State of New Mexico
Energy, Minerals and Natural Resources Department

David R. Catanach, Division Director
Oil Conservation Division

SUNDRY NOTICES AND REPORTS ON WELLS

8. Well Name and No.
Rosa Unit 315

ROSA UNIT #315

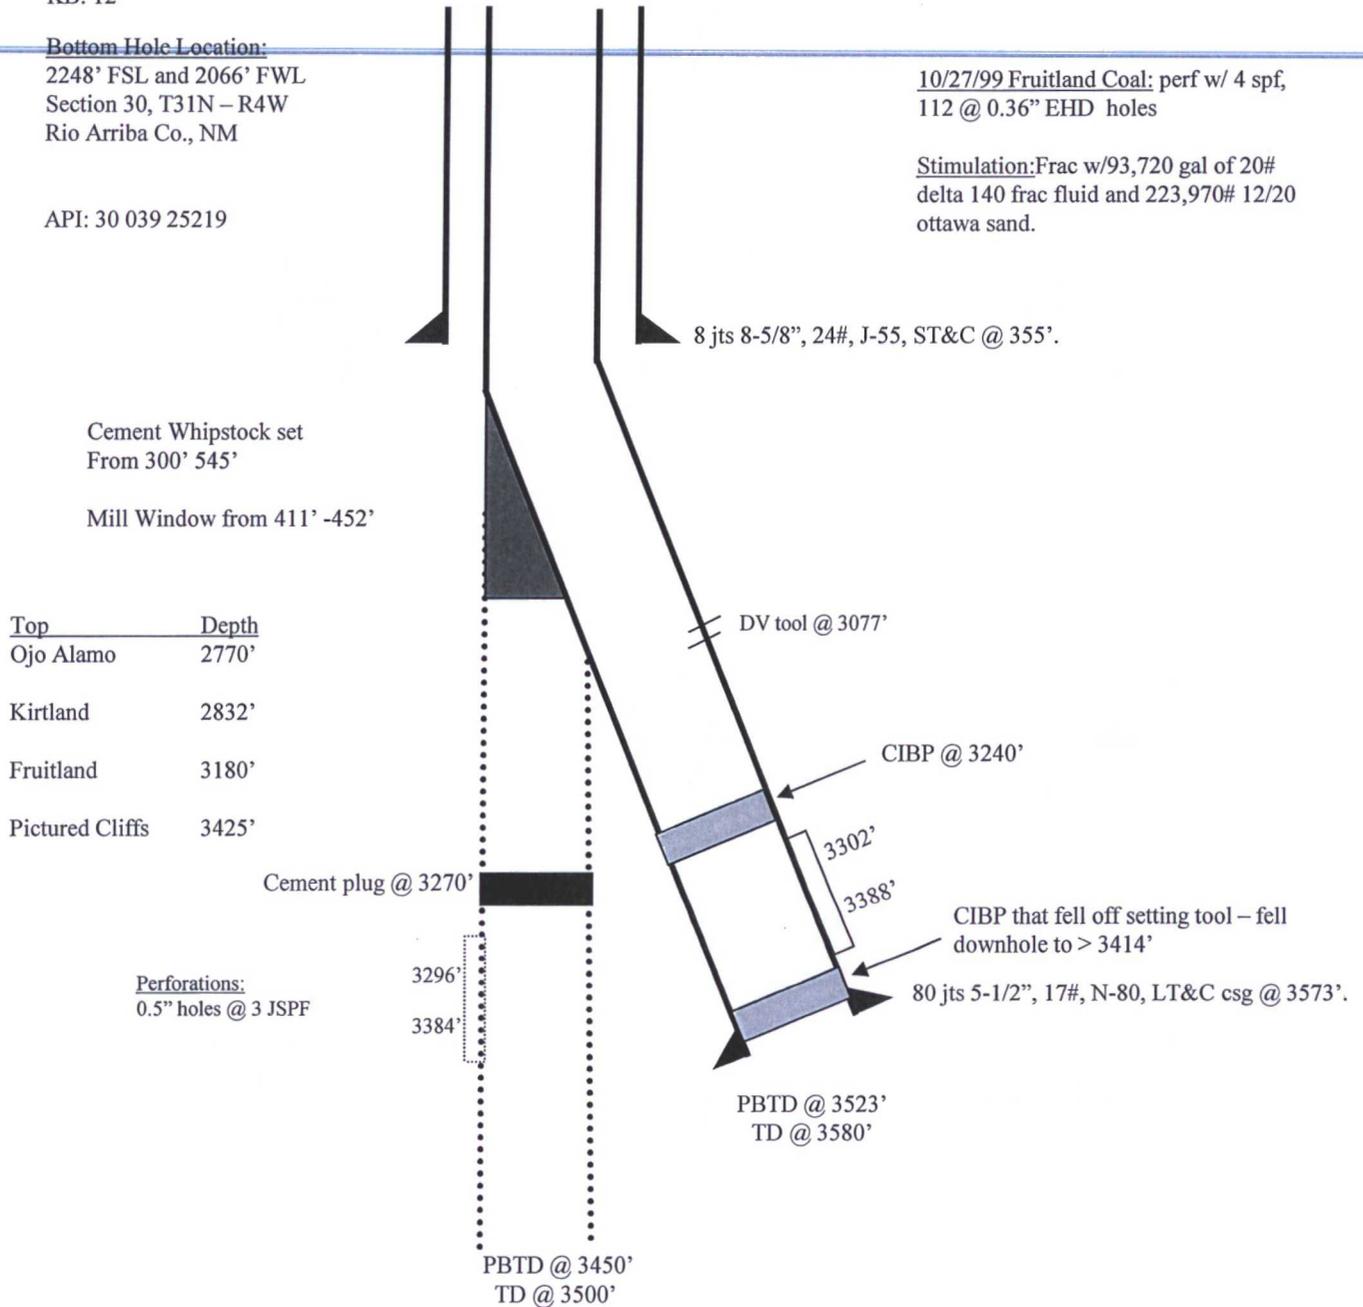
WPX did not set CIBP as proposed previously of a setting depth @ 3252' & is requesting a TA status w/ new CIBP setting depth @ 3240'. Notified Brandon Powell(OCD) & William Tambekou(BLM).

** TA approved until 5/1/2018*
